APPLICATION NO.	FILING DATE	FIRST NAMED INVENTOR	ATTORNEY DOCKET NO.	CONFIRMATION NO.
10/522,044	01/19/2005	Peter Drott	PCT10483US	3988
23122	7590	07/13/2007	EXAMINER	
RATNERPRESTIA			LEE, GILBERT Y	
P O BOX 980			ART UNIT	
VALLEY FORGE, PA 19482-0980			PAPER NUMBER	
			3673	
			MAIL DATE	
			DELIVERY MODE	
			07/13/2007	
			PAPER

<p align="center">Office Action Summary</p>	<p>Application No.</p> <p align="center">10/522,044</p>	<p>Applicant(s)</p> <p align="center">DROTT ET AL.</p>	
	<p>Examiner</p> <p align="center">Gilbert Y. Lee</p>	<p>Art Unit</p> <p align="center">3673</p>

DETAILED ACTION

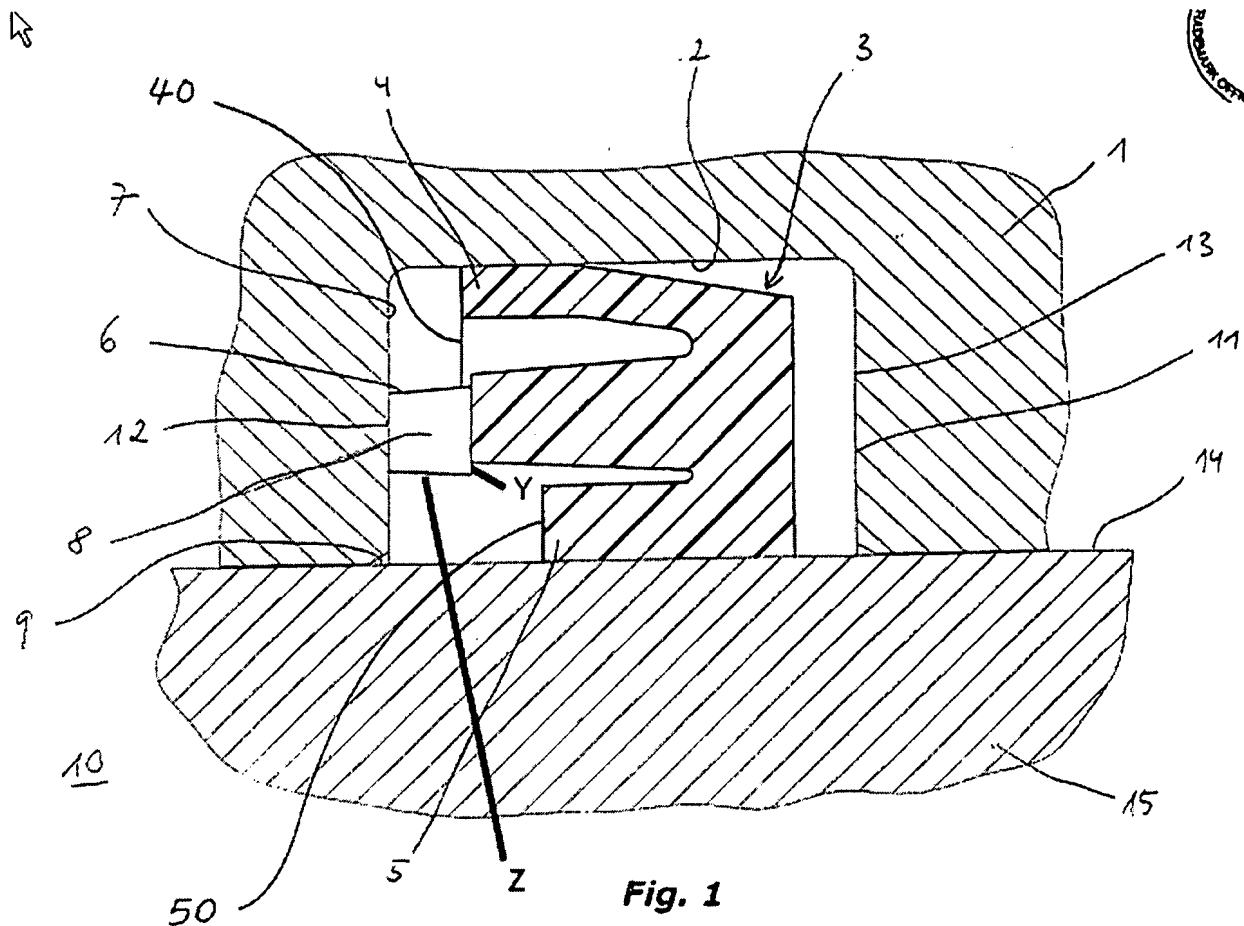
For reference characters A-F refer to the Examiner's Attachment 1.

Regarding claim 15, the Zollner reference, as best understood, discloses a cylinder-and-piston unit (Col. 1, Lines 5-15) comprising a cylinder (5), a piston (6) and a sealing collar (19 or 22), the sealing collar inserted in a groove (e.g. groove of element 5 containing elements 19 and 21 or elements 21 and 22) that is recess in an interior wall surface of the cylinder and comprising an outside sealing lip (B) and an inside sealing lip (A), the outside and inside sealing lips each having a free end (i.e. the ends facing

downwards in Fig. 2), the sealing collar further including a circumferential extension (C) that extends in parallel to the sealing lips (Fig. 2), is arranged radially between the outside sealing lip and the inside sealing lip and projects axially beyond the free ends of the outside and inside sealing lips (Fig. 2), the circumferential extension being configured to contact a side wall (e.g. wall of element E in contact with element 19 or wall of element 21 in contact with element 22) in the groove (Fig. 2) and maintain the free ends of the outside and inside sealing lips out of contact with the sidewall (Fig. 2).

Regarding claim 20, the Zollner reference, as best understood, discloses the extension being provided with radial apertures (F). Note that the apertures are capable of allowing pressure fluid to pass through in a radial direction.

Regarding claim 25, the Zollner reference, as best understood, discloses the free end of the circumferential extension being provided with radial apertures (F). Note that

the apertures are **capable of** allowing pressure fluid to pass through in a radial direction.
